Ohio Power Siting Board
Staff Investigation Report and Recommendation

Case No.: 13-0360-EL-BGA

Project: Amendment to Buckeye I Wind Farm (08-0666-EL-BGN)

Report Date: November 1, 2013

Overview Map

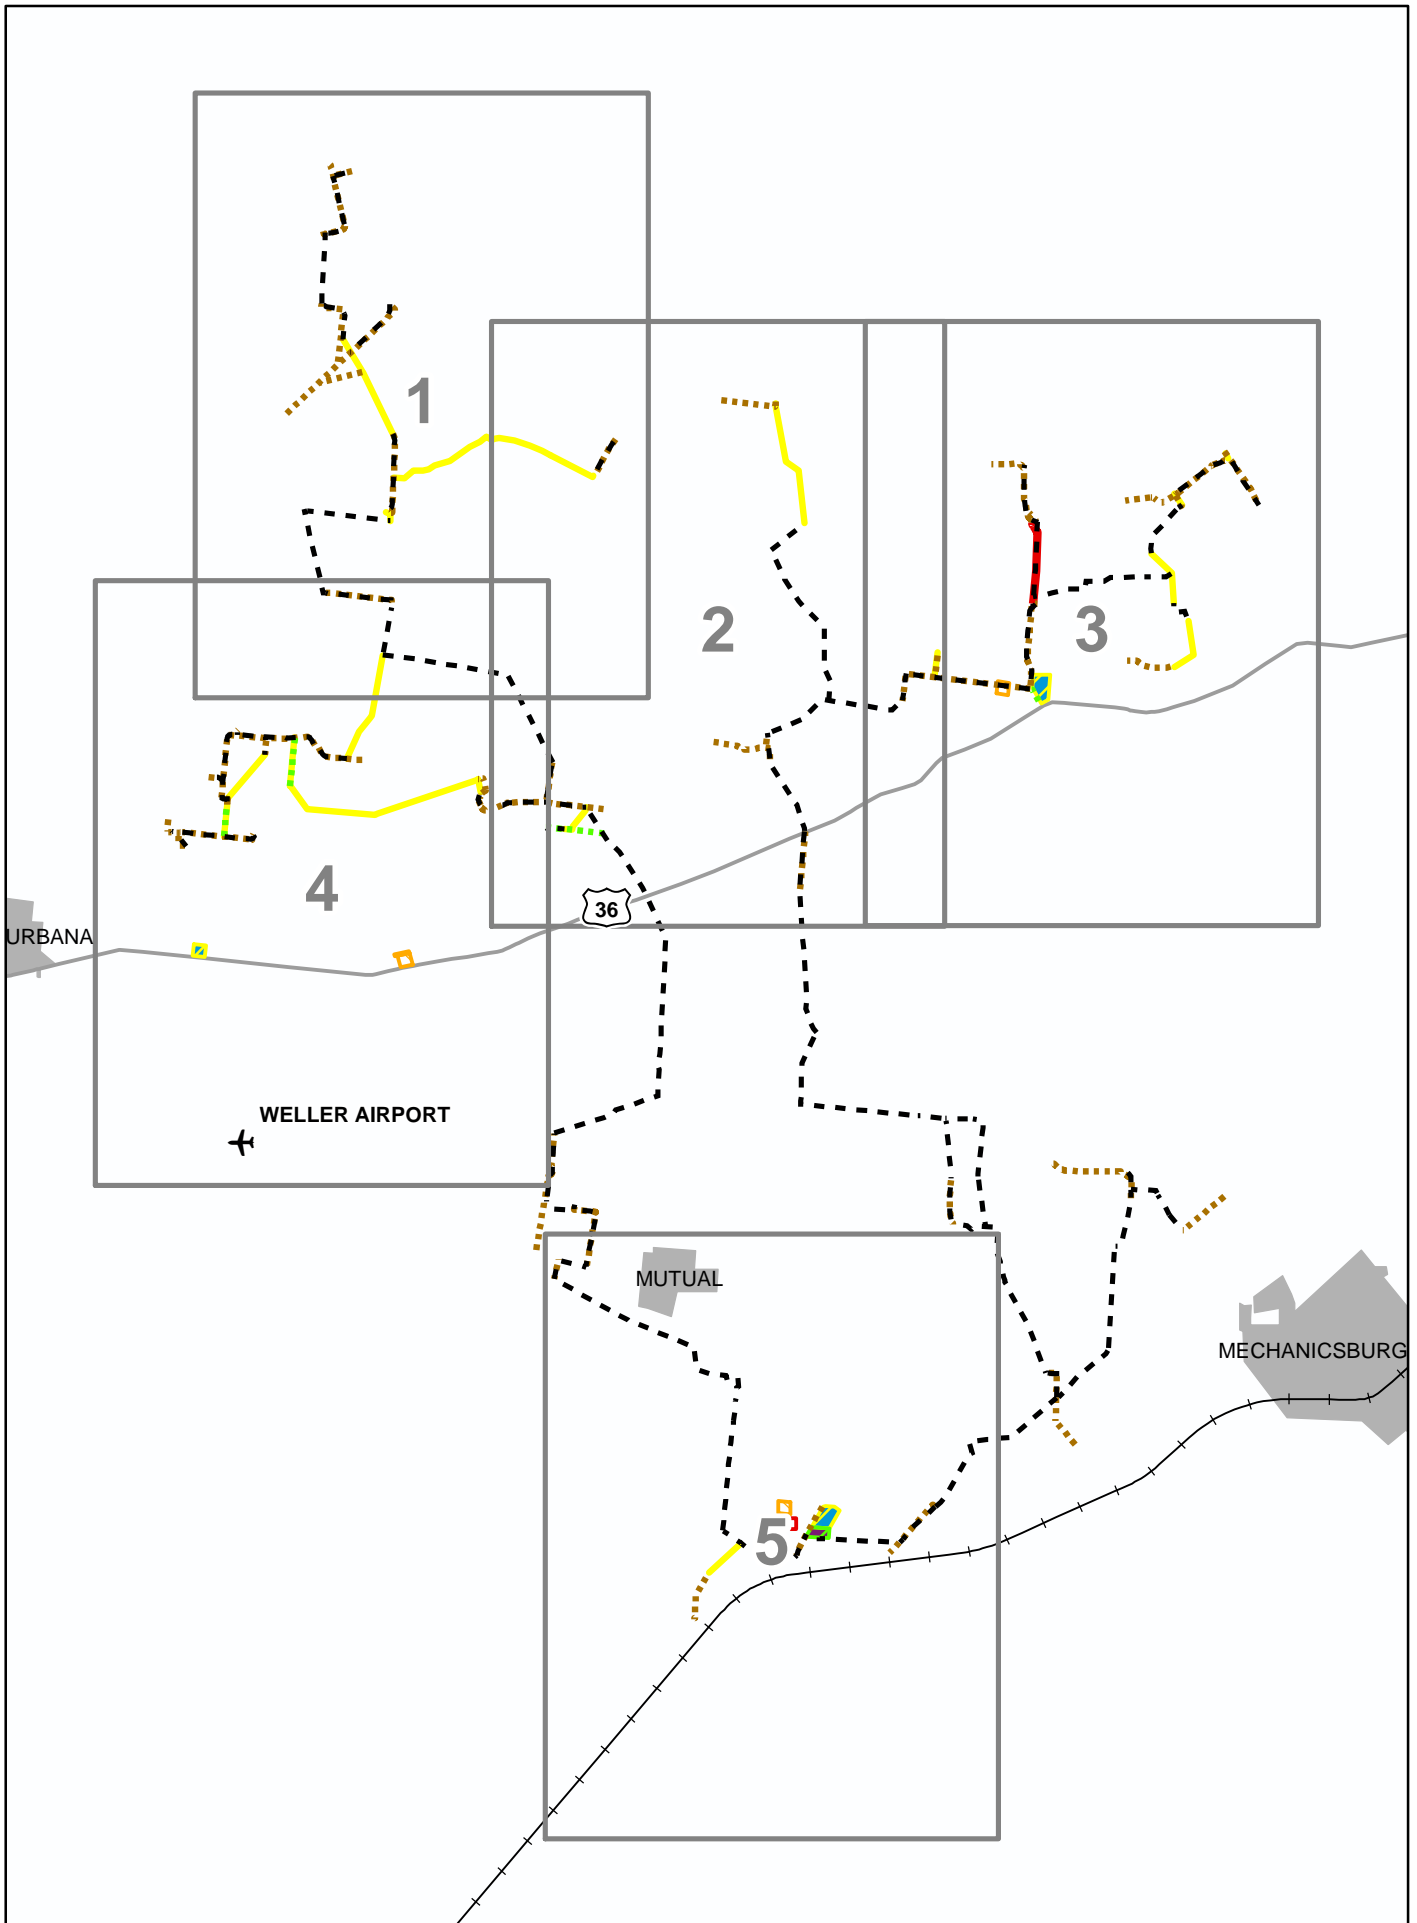
Of the 41.1 miles, Staff determined that there are 7.32 miles that have not been reviewed and approved in the initial Buckeye I or Buckeye II proceeding. Segments of the electric collection system that have been previously reviewed and approved by the Board were not further analyzed, but rather Staff focused its review in this proceeding on the 7.32 miles of new collection line routing. The maps attached at the end of this report identify the segments of the electric collection system that comprise the 7.32 miles.
